Access Compliance Report

Public Rights-of-Way

(Curb Ramps)

Intersection ID: 52599	Main Street: W_TYVOLA_RD	Cross Street: POTOMAC_RIVER_PY	Location: NW
ADA ID: 8E929AD83A82	Ramp Type: Perpendicular Diagonal	Initial Pass/Fail: Pass	Overall Compliance: No
			Severity Score: 2.75

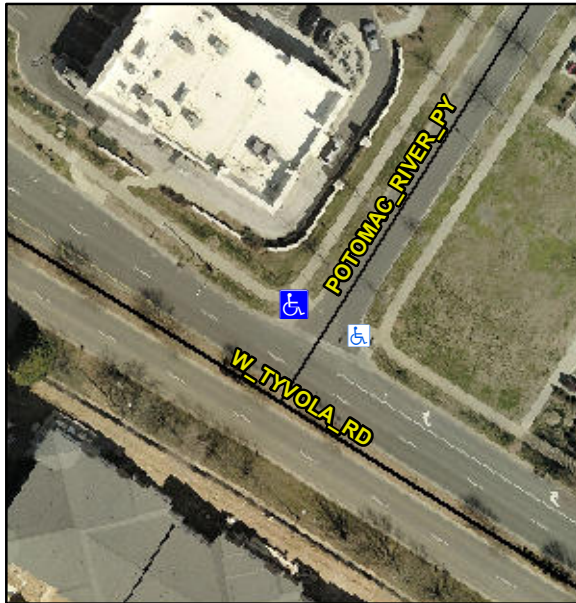
Not Found, R304.5.3, R305.1.4, R305.2

Compliance	Description	Data	Compliance	Description	Data
N/A	Ramp Length (in)	92.0	Yes	Ramp Slope (%)	7.6
Yes	Ramp Width (in)	50.0	No	Ramp XSlope (%)	2.6
N/A	Flare Type LT	Sloped	N/A	Flare Type RT	N/A
N/A	Flare Slope LT (%)	4.2	N/A	Flare Slope RT (%)	7.6
N/A	Flare Traversable LT?	No	N/A	Flare Traversable RT?	No
Yes	Landing Length (in)	71.0	Yes	DWS Provided?	Yes
Yes	Landing Width (in)	50.0	Yes	DWS Contrast?	Yes
Yes	Landing Slope (%)	1.9	Yes	DWS Length (in)	24.5
No	Landing X Slope (%)	2.1	No	DWS Full Width?	No
N/A	Landing Curb? (Y/N)	No	No	DWS Offset (in)	5.5
N/A	Shared Landing?	No			
Yes	Gutter Ponding?	No	Yes	Gutter Slope (%)	2.3
Yes	Gutter Lip Ht (in)	0.0	Yes	Gutter X Slope (%)	0.5
N/A	Painted X Walk1?	No	N/A	Painted X Walk2?	No
	X Walk 1 Direction	To SW		X Walk 2 Direction	To SE
N/A	X Walk 1 Width (in)	N/A	N/A	X Walk 2 Width (in)	N/A
	X Walk 1 Slope (%)	5.9		X Walk 2 Slope (%)	1.8
	X Walk 1 X Slope (%)	3.6		X Walk 2 X Slope (%)	2.1

Remove & Replace Curb Ramp With Two New Directional Ramps or Equivalent.
